**BOARD OF ZONING ADJUSTMENT
STAFF REPORT****Date: February 5, 2018****CASE NUMBER**

6157

Mobile Area Chamber of Commerce Foundation (Frank Lott, Agent)

VARIANCE REQUEST**FRONTAGE:** To allow a 1,097 square foot pedestrian forecourt in a T5.1 Sub-District within the Downtown Development District.**SIGN:** To allow an individual storefront sign 10' in height in a T5.1 Sub-District within the Downtown Development District.**BUILDING MATERIALS:** To allow metal siding and roofing as well as vertical polycarbonate skylights in a T5.1 Sub-District within the Downtown Development District.**PARKING:** To allow parking spaces without wheel stops in a T5.1 Sub-District within the Downtown Development District.**ZONING ORDINANCE
REQUIREMENT****FRONTAGE:** The Zoning Ordinance prohibits pedestrian forecourts exceeding 600 square feet in a T5.1 Sub-District within the Downtown Development District.**SIGN:** The Zoning Ordinance limits individual storefront signs to 2' in height in a T5.1 Sub-District within the Downtown Development District.**BUILDING MATERIALS:** The Zoning Ordinance does not allow metal siding, roofing, or vertical polycarbonate skylights in a T5.1 Sub-District within th

PROPOSED SITE PLAN

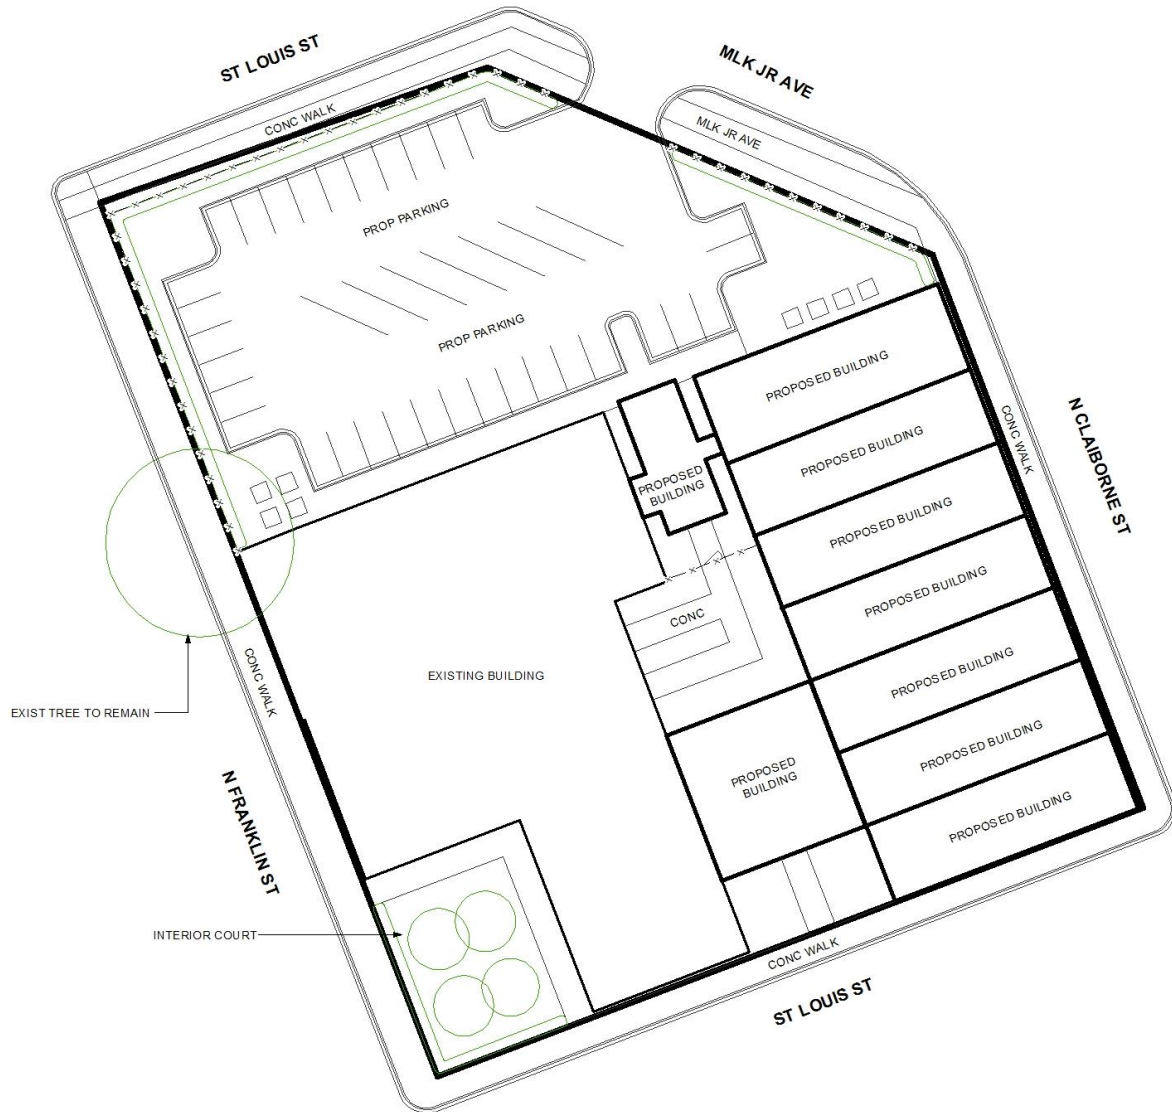
Any on-site parking, including ADA handicap spaces, shall meet the minimum standards as defined in Section 64-6 of the City's Zoning Ordinance. The shorted length of parking spaces to assume "overhang" is not advisable as not all drivers pull over the curb. Site plan appears to have adequate space for standard parking space dimensions. In addition, handicap spaces are required (not shown) and the space dimensions for accessible parking can not be given a variance by this board.

Upon reviewing the site plan staff noticed that although on-site parking is not required in the Downtown Development District, the parking spaces do not have any designated handicap accessible spaces. The applicant may wish to review the need for accessible parking and make adjustments to the site plan as needed.
